# rts\_forward\_timer duration concern

Jeff Slavick – Broadcom  
Xuebo Wang – Huawei

# The concern is with rts\_forward\_timer min duration

Figure 178B-9—RTS update state diagram

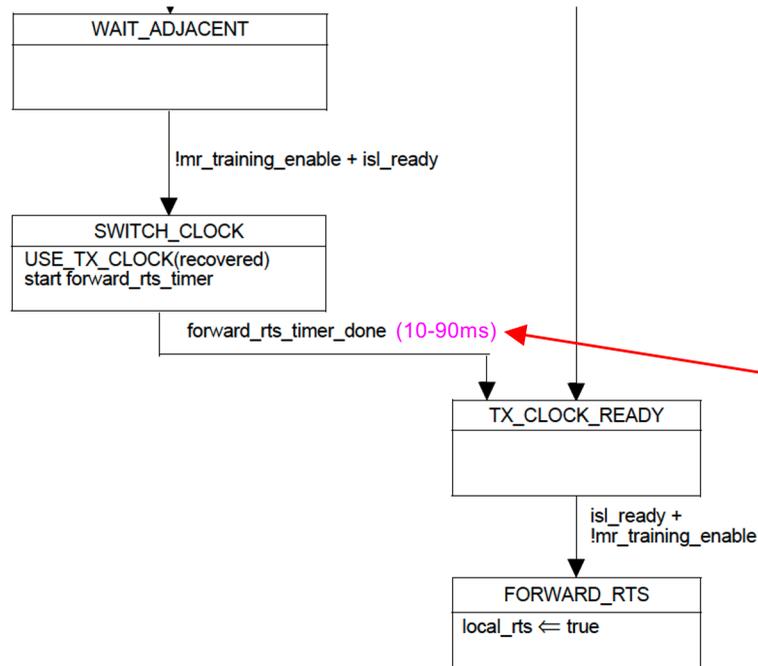
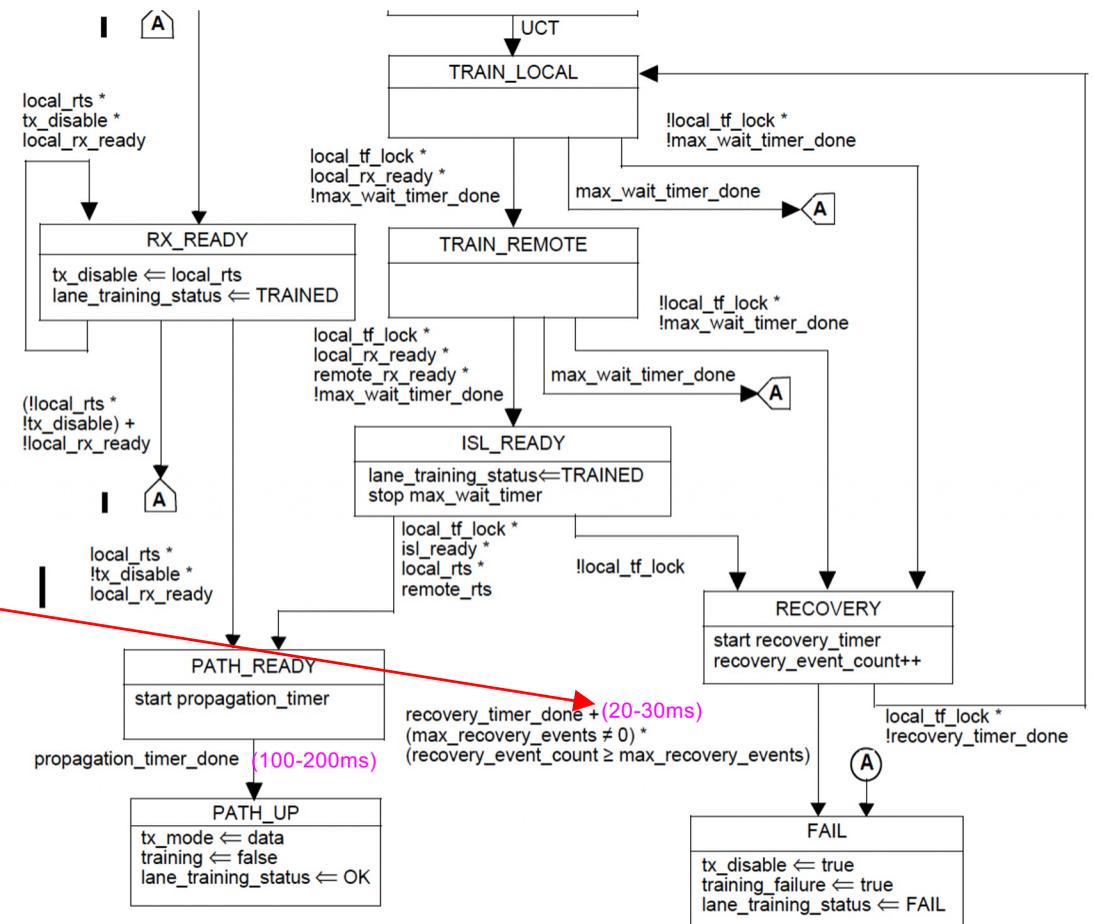
One side could go to FAIL while the other goes to PATH\_UP due to RTS asserting before recovery\_timer expires.

Figure 178B-9—RTS update state diagram

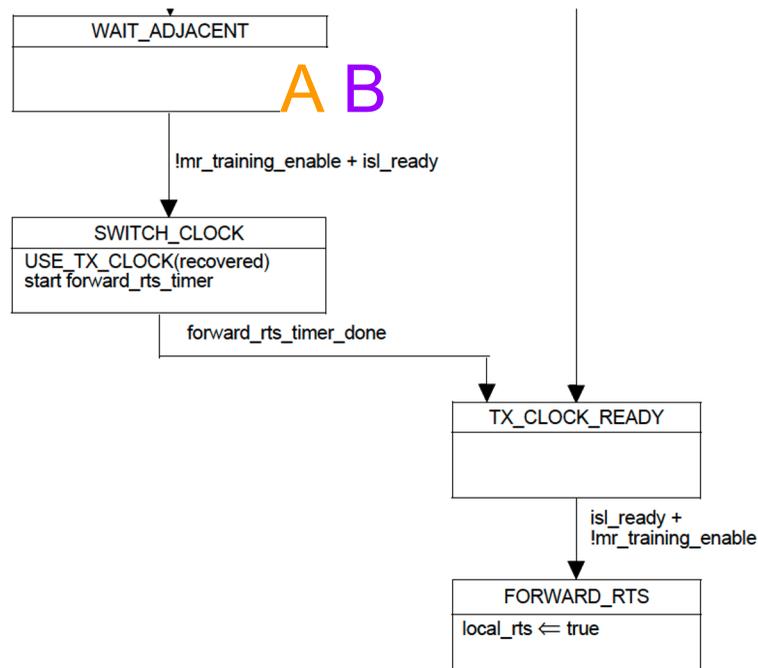
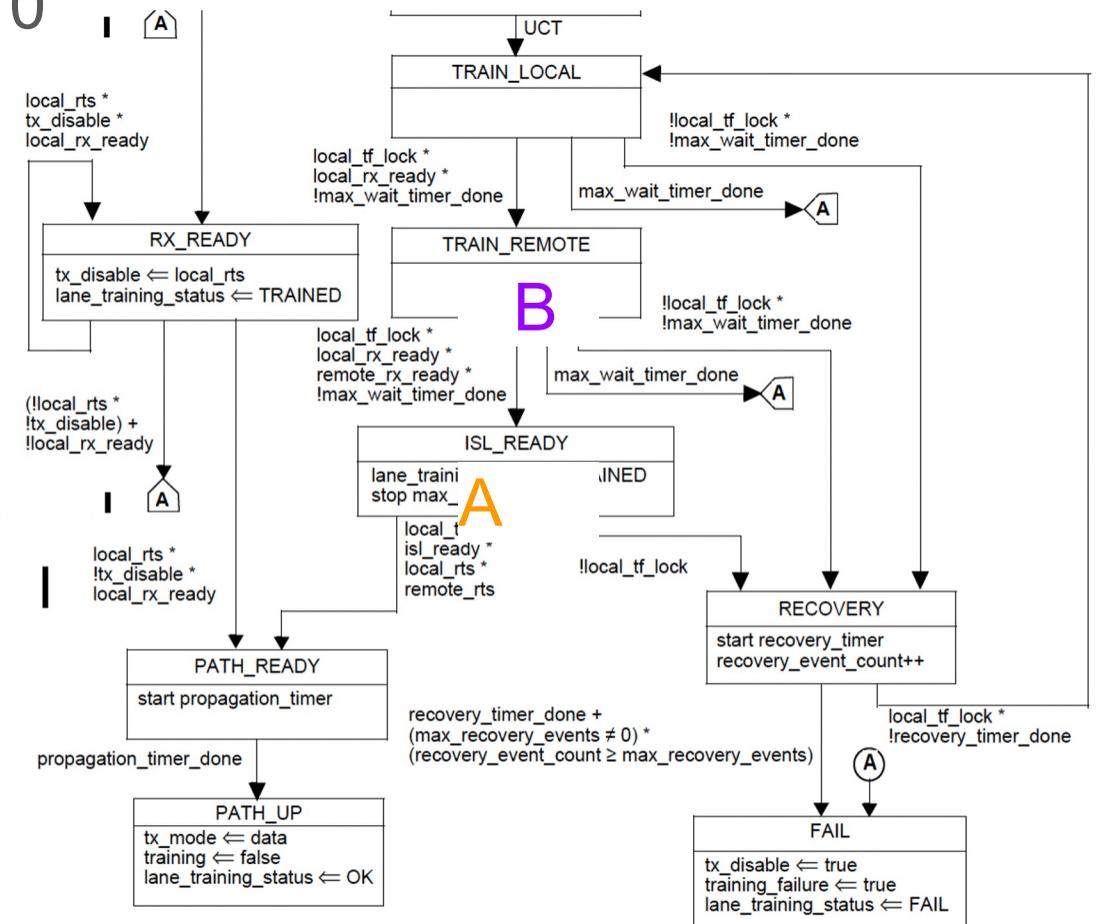
Peer interfaces A and B are in ISL\_READY and TRAIN\_REMOTE states in Fig. 178B-10 and WAIT\_ADJACENT in Figure 178B-9.

Figure 178B-9—RTS update state diagram

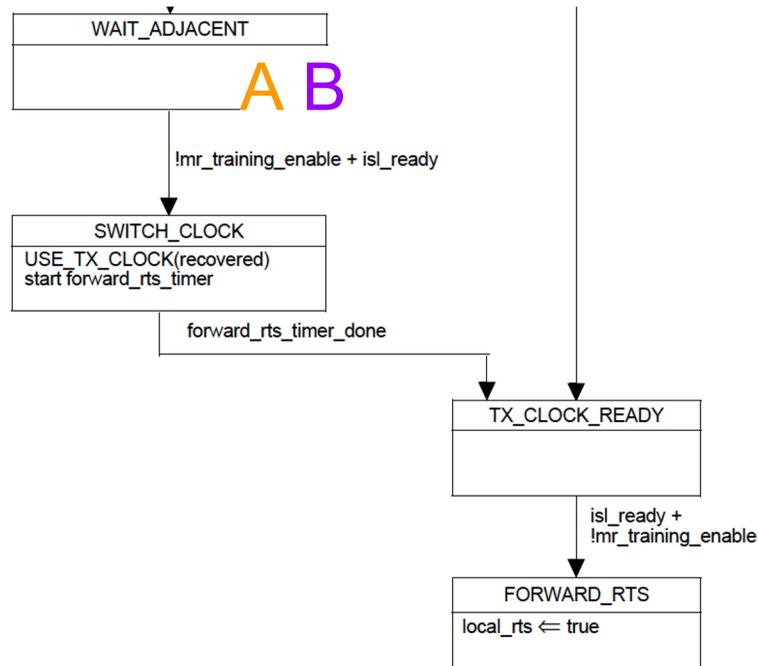
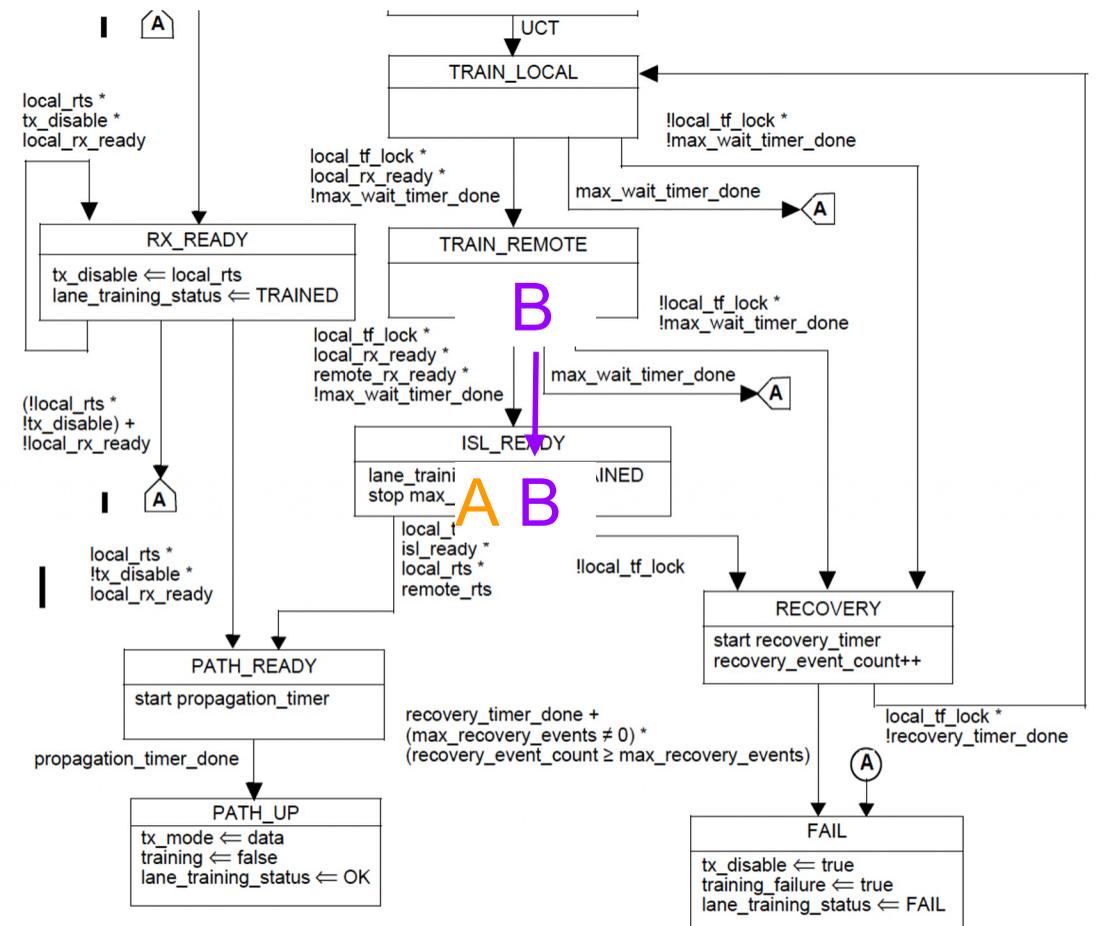
Interface B transitions to ISL\_READY.

Figure 178B-9—RTS update state diagram

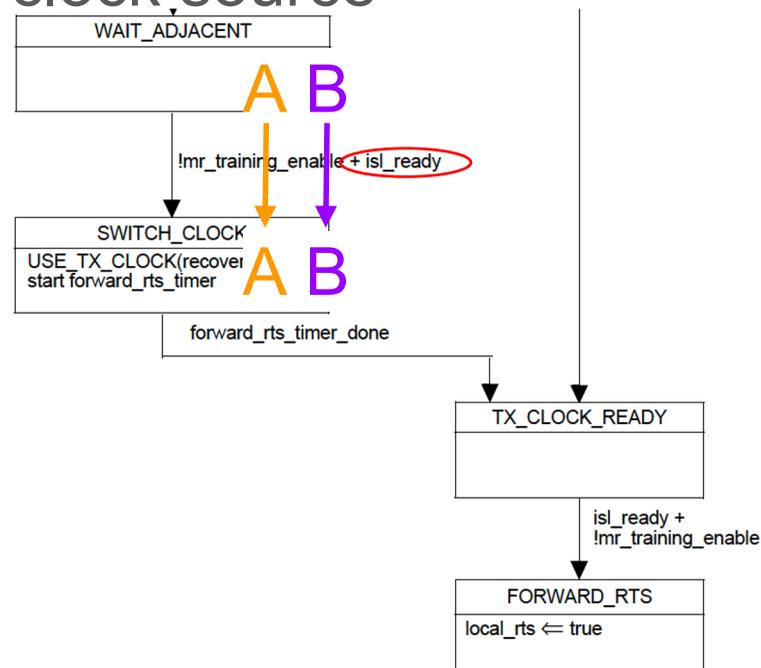
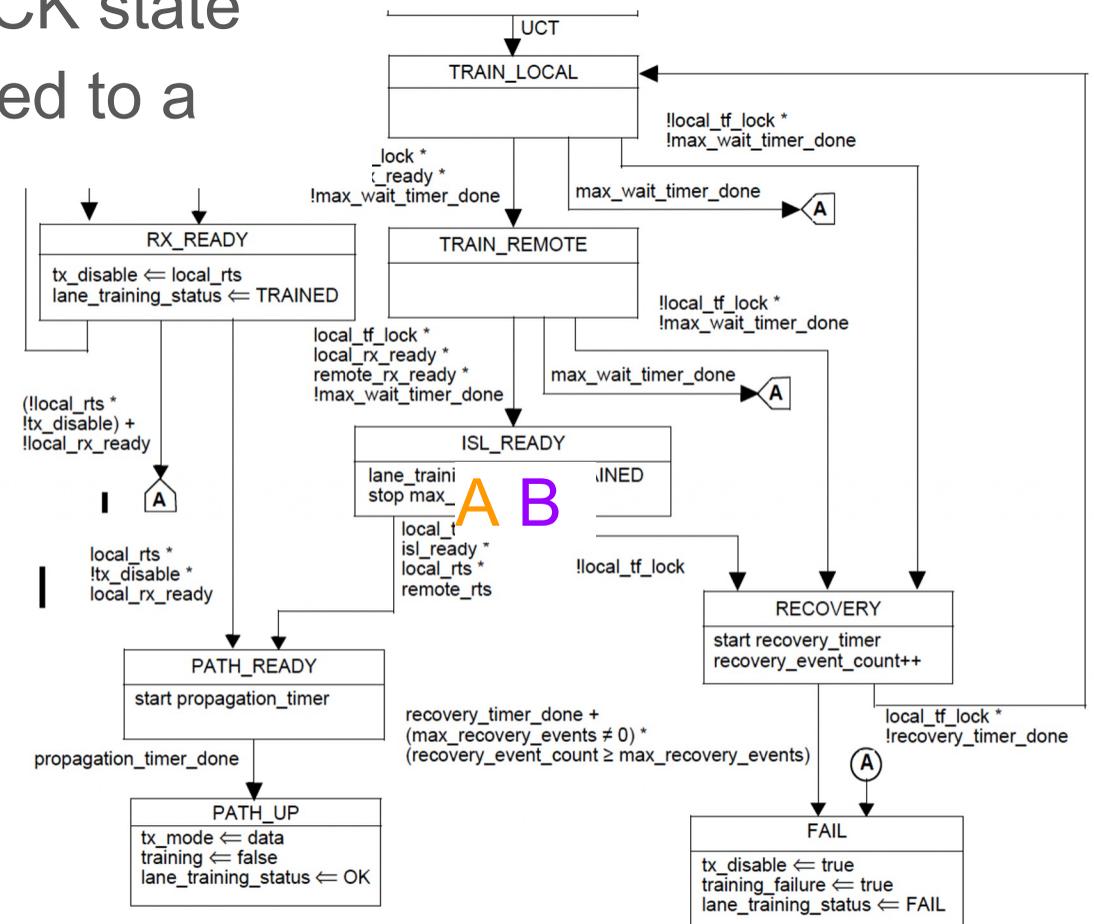
isl\_ready goes true once both interfaces are in ISL\_READY state. Both interfaces transition to SWITCH\_CLOCK state where the transmit clock reference is updated to a forwarded clock source

Figure 178B-9—RTS update state diagram

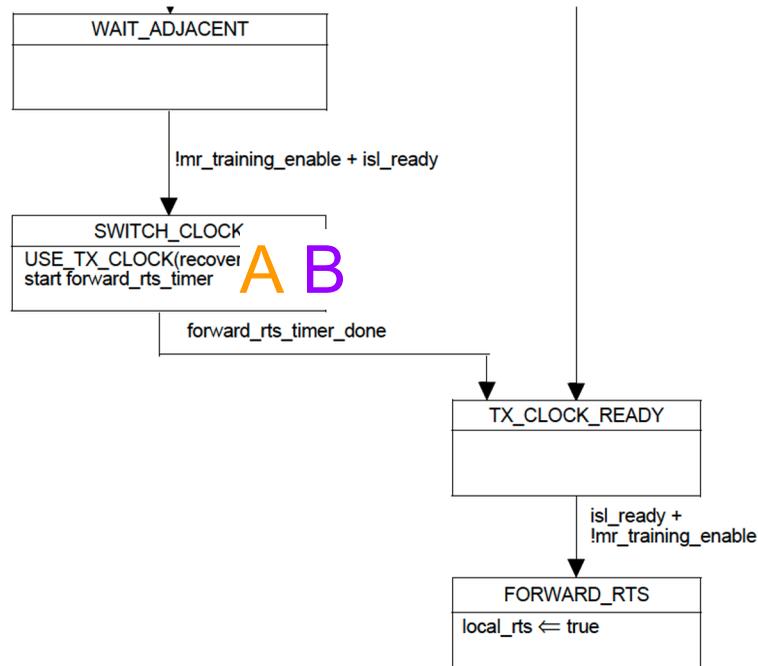
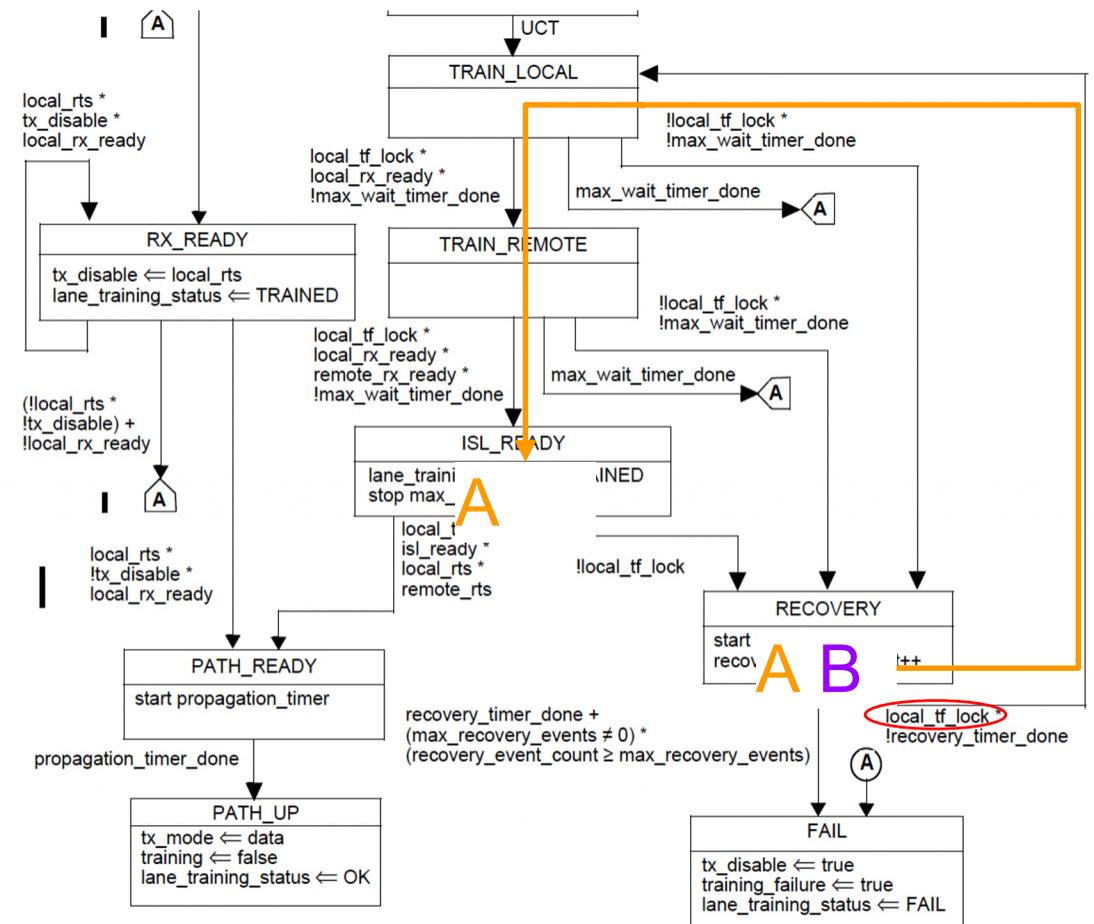
Interface A regains local\_tf\_lock

Interface B does not regain local\_tf\_lock

Figure 178B-9—RTS update state diagram

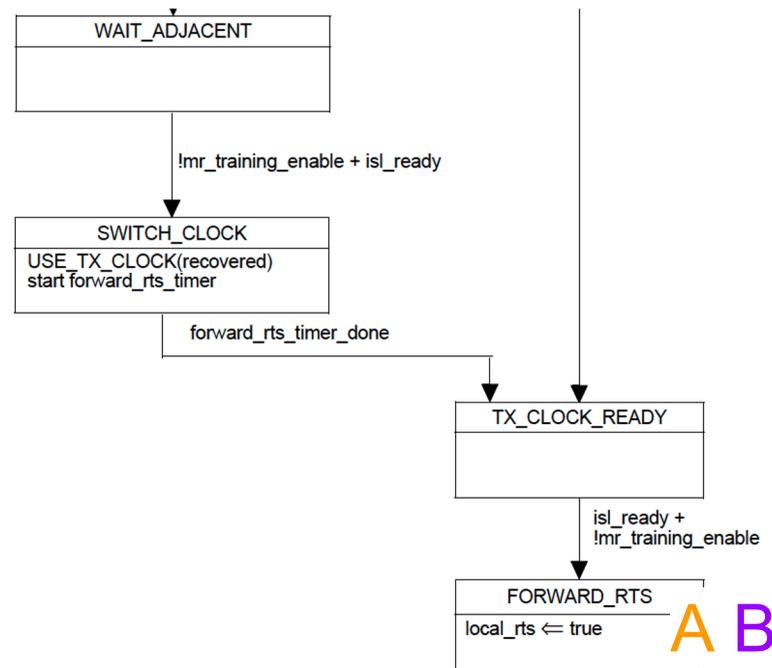
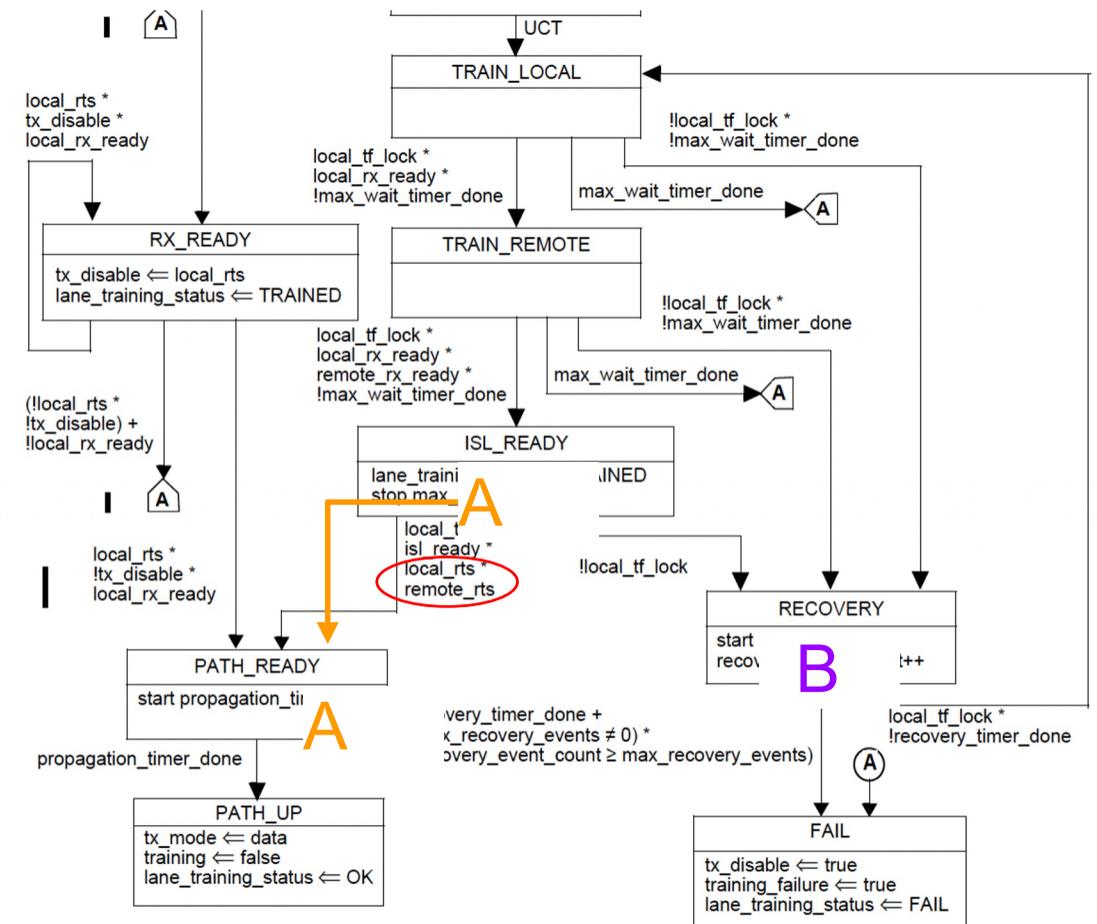
local\_rts and remote\_rts are both TRUE.  
Interface A moves to PATH\_READY

Interface B is still in RECOVERY.

Figure 178B-9—RTS update state diagram

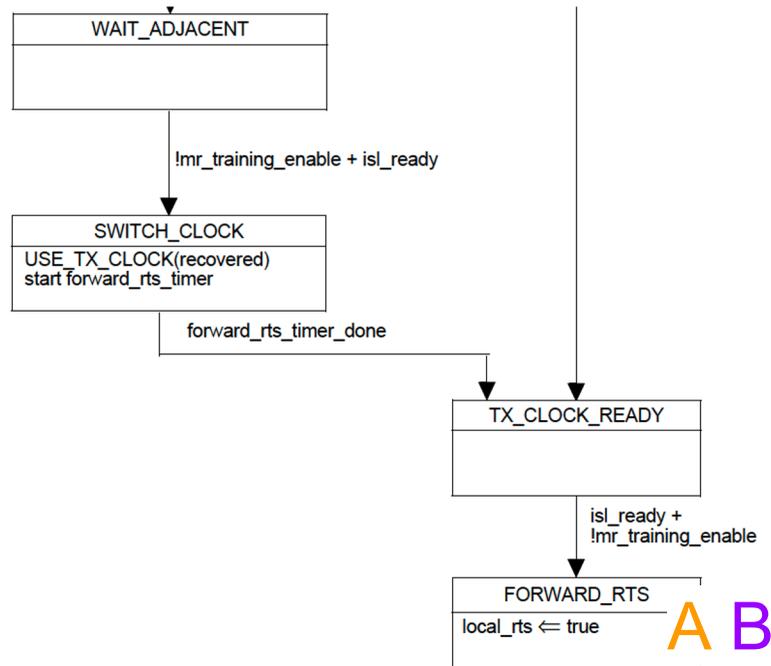
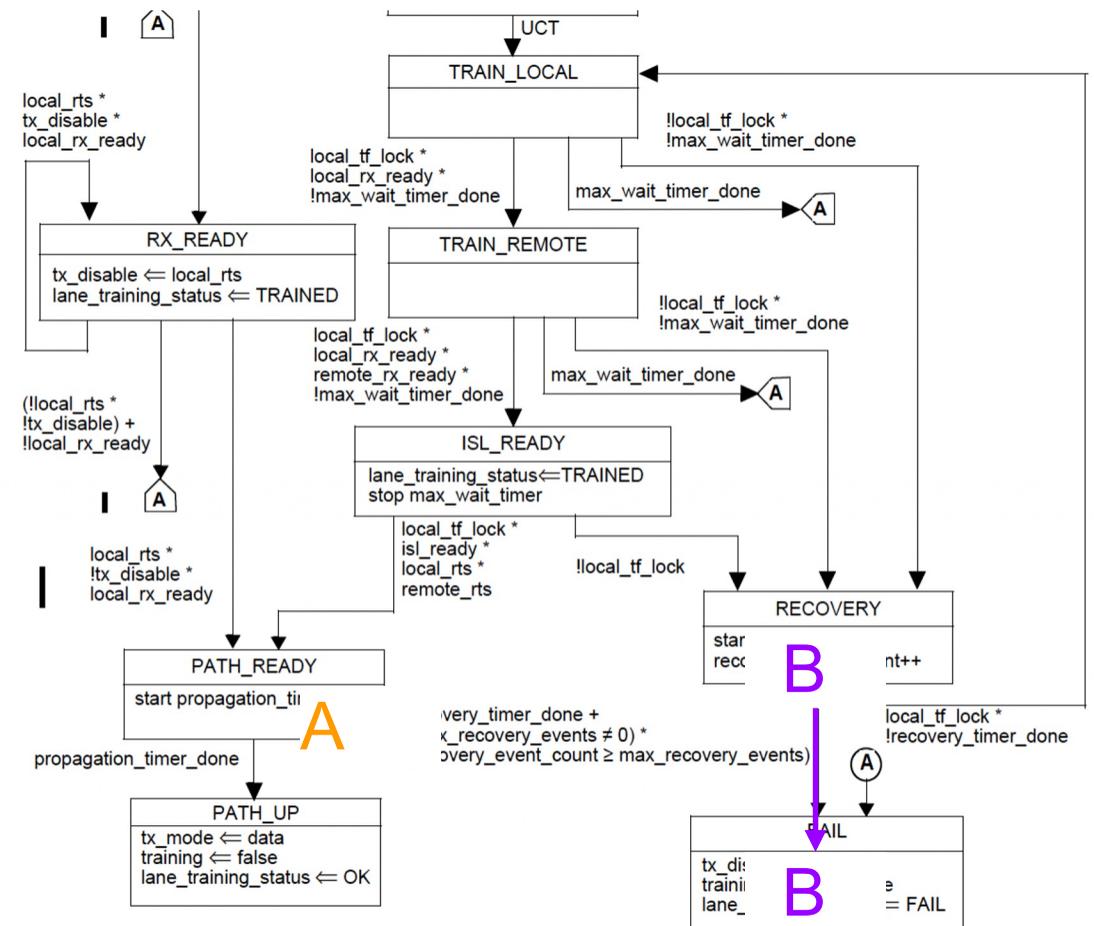
Interface B moves to FAIL as its recovery\_timer expires without regaining local\_tf\_lock
